**202 HILLTOP DRIVE
UPPER NYACK, NY 10960**

PROJECT NARRATIVE

- WALLS TO BE NATURAL STONE
 - EXTENSION OF CURBING INTO SEEDED AREA ON BLISS LANE
 - NO LIGHTING TO BE LOCATED ON SOUTH SIDE OF PROPERTY
- COMMENT PROVISION RESPONSES.**
ORIGINAL COMMENTS PROVIDED BY:
PLANNING BOARD OF THE VILLAGE OF UPPER NYACK
WEDNESDAY, NOVEMBER 18, 2009

FINAL SITE PLAN

A SITE PLAN
SCALE: 1" = 20'-0"

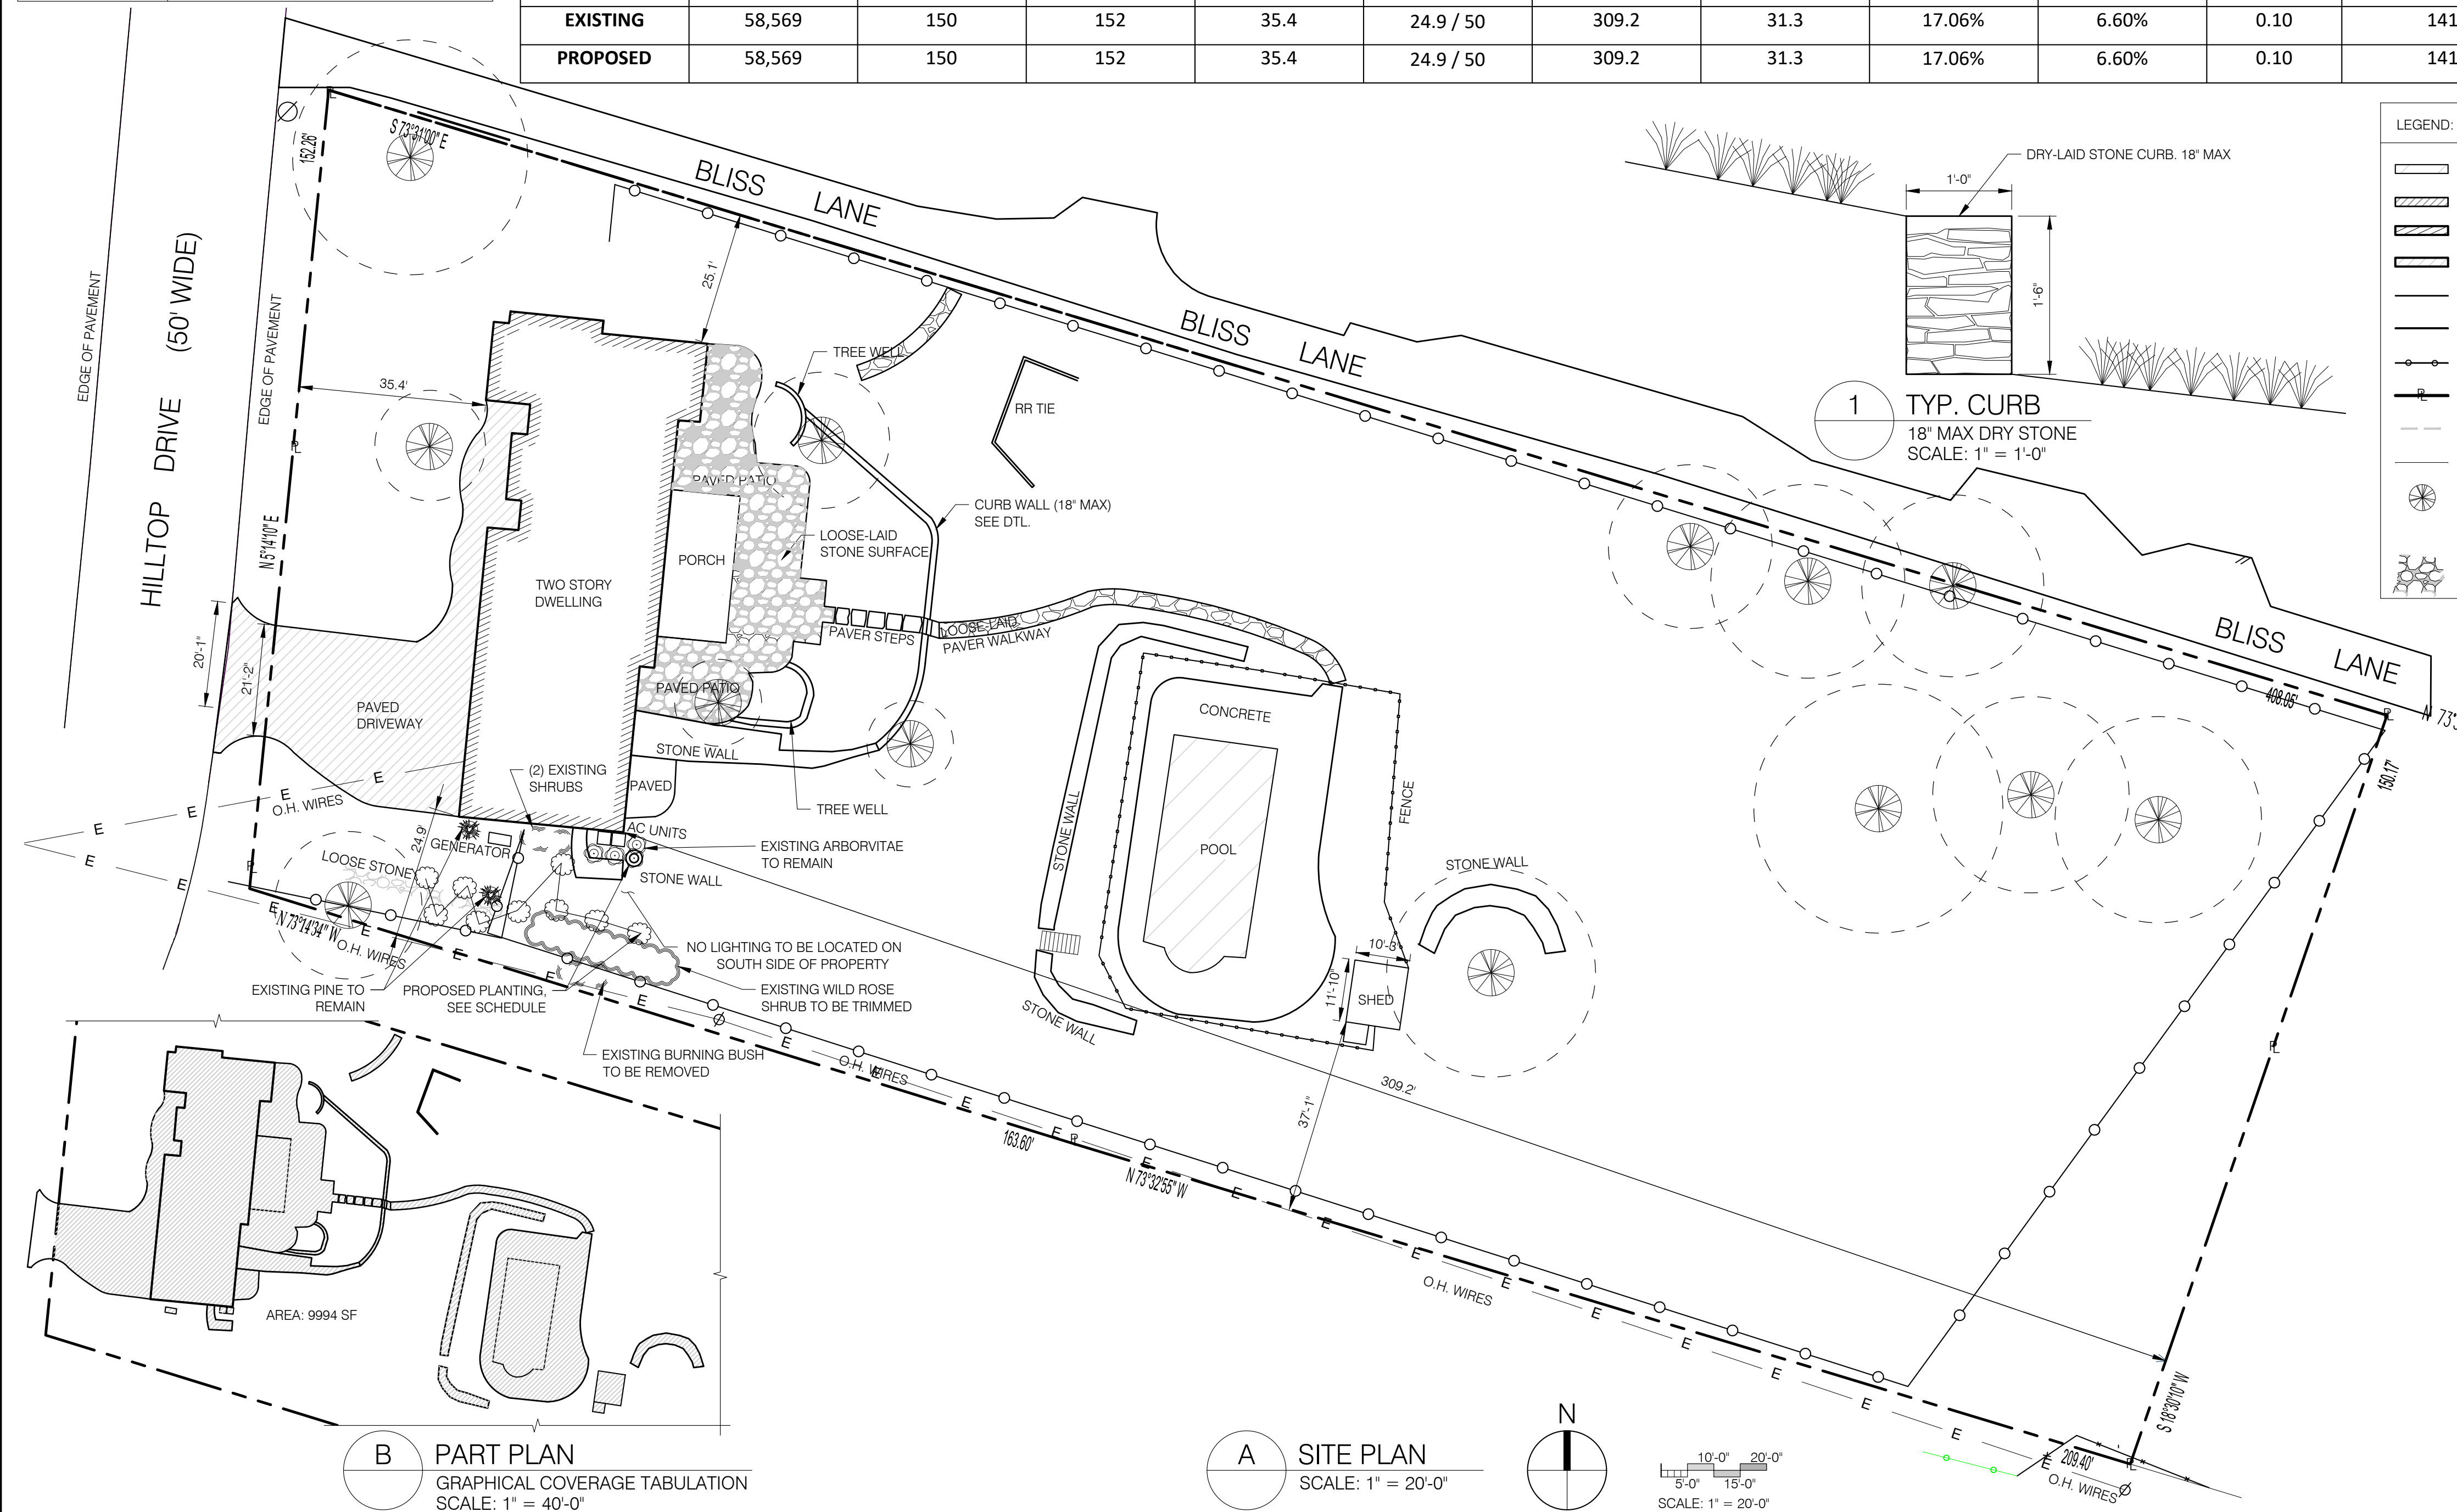
COMMENT RESPONSES FOLLOW
- SHOW DIMENSIONS OF POOL HOUSE POOL HOUSE DIMENSIONS HAVE BEEN ADDED
 - RELOCATE AC UNIT/COMPRESSOR ON SOUTH SIDE OF THE HOUSE TO BACK OF HOUSE EXISTING SLIDING DOORS PRESENT AT SOUTH SIDE OF HOUSE, AC COMPRESSOR INSTALLED AS SHOWN AND SCREENED WITH RUBBLE EMBANKMENT AND PLANTING SCREENING

- ADD NOTE STATING WALLS TO BE NATURAL STONE (NOT CONC.) NOTE ADDED
 - ADD NOTE STATING EXTENSION OF CURBING INTO SEEDED AREA ON BLISS LANE NOTE ADDED
 - ADD NOTE STATING NO LIGHTING TO BE LOCATED ON SOUTH SIDE OF PROPERTY NOTE ADDED

A COMPARISON PLAN
 SCALE: 1" = 20'-0"

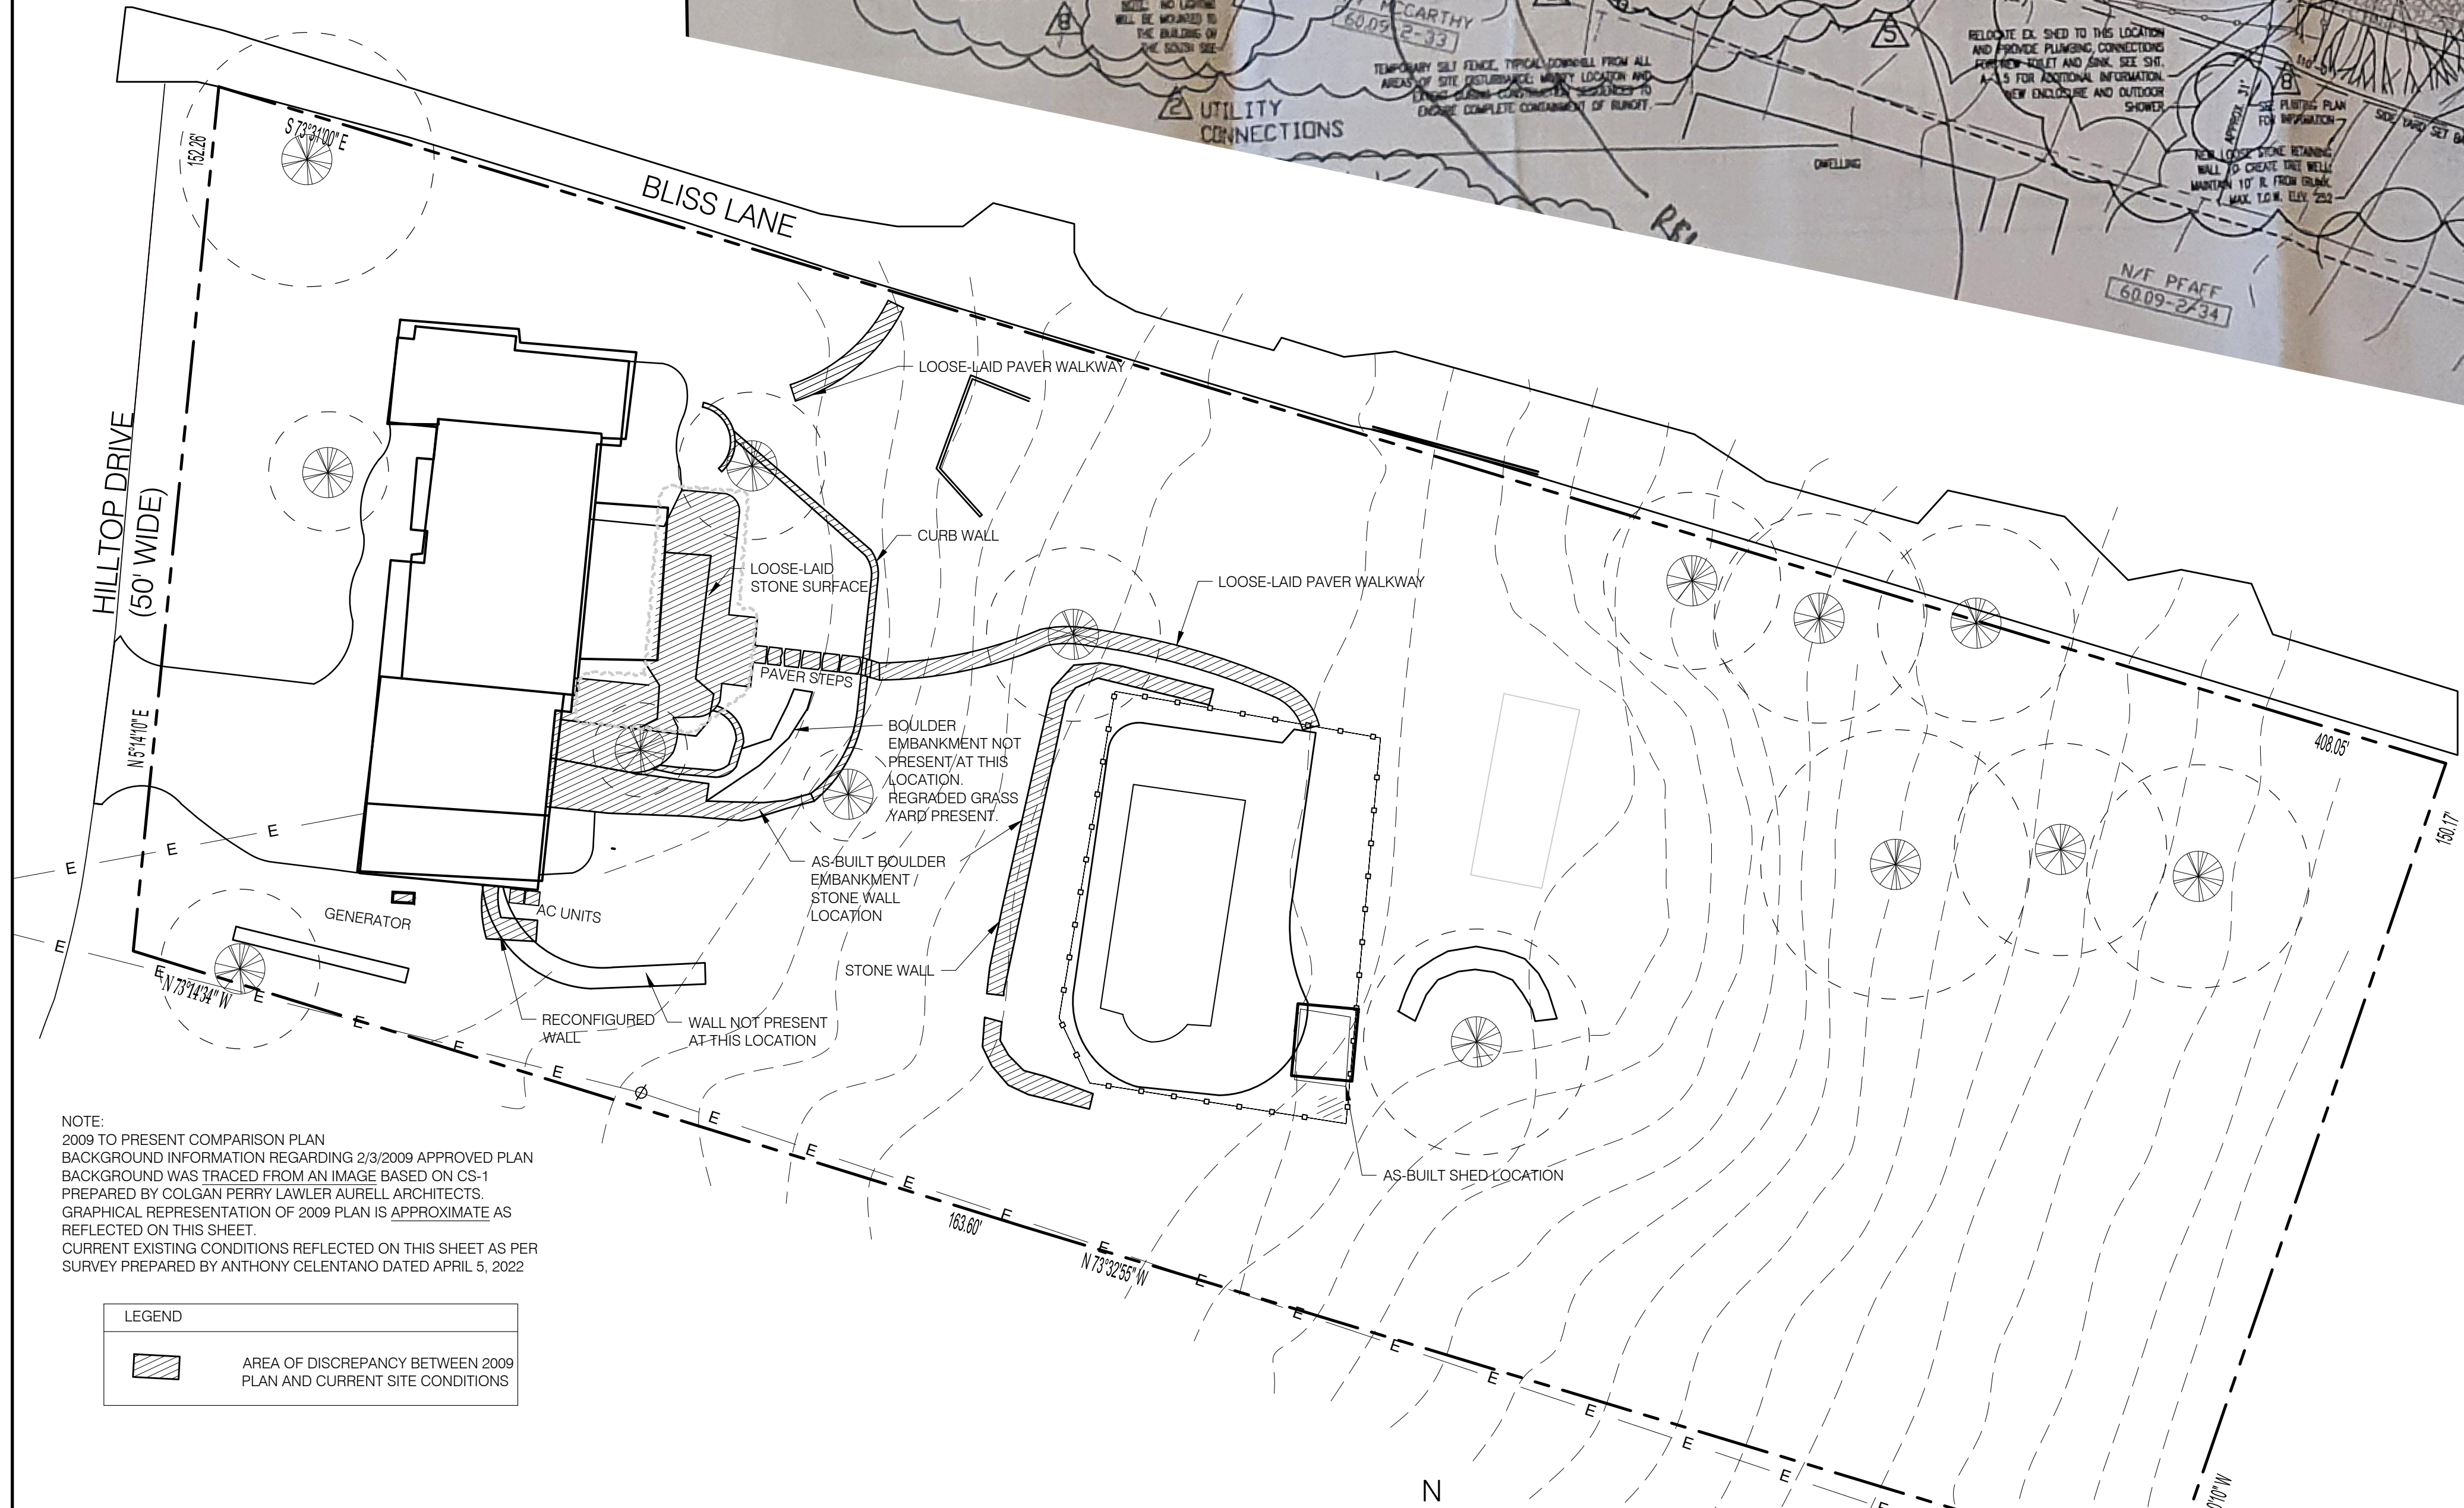
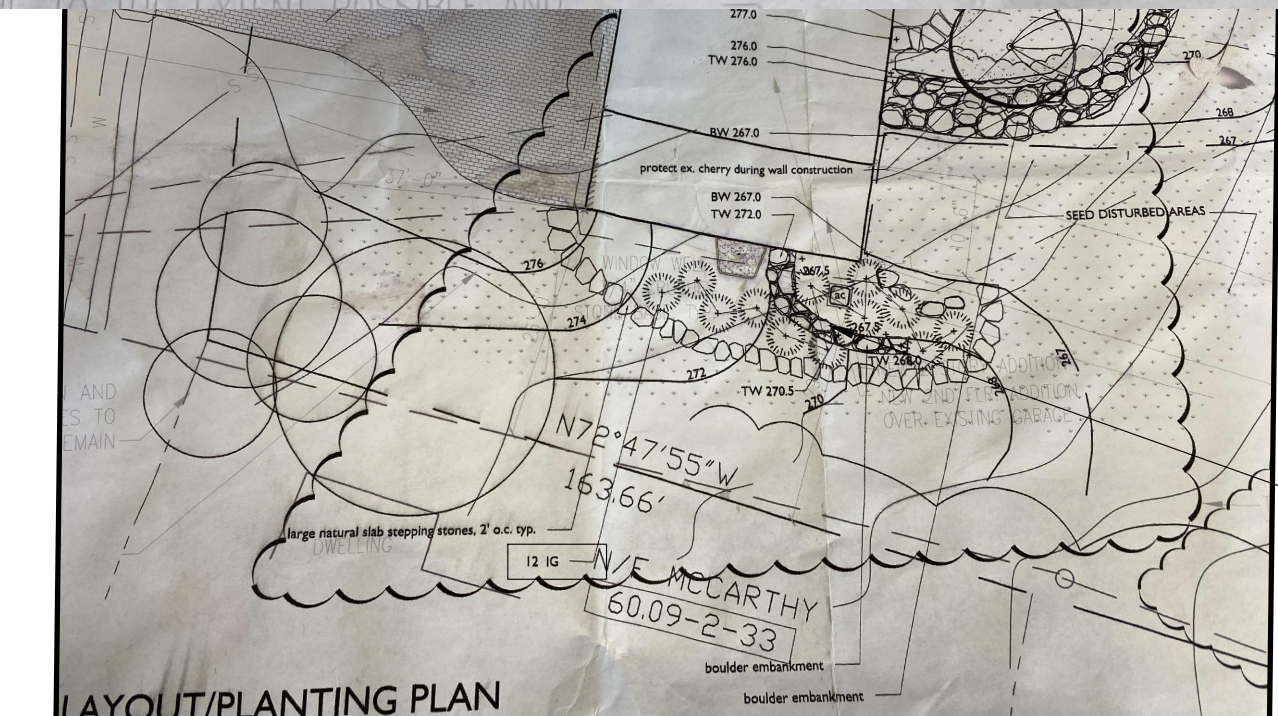
AREA OF DISCREPANCY BETWEEN 2009 PLAN AND CURRENT SITE CONDITIONS

(12) ORIGINALLY PROPOSED INKBERRY, 2.5' - 3' IN HEIGHT.

PROPOSED SUBSTITUTION:
 EXISTING 3 ARBORVITAE
 EXISTING 2 WILD ROSE
 + 1 ARBORVITAE
 + 7 AMERICAN HOLLY
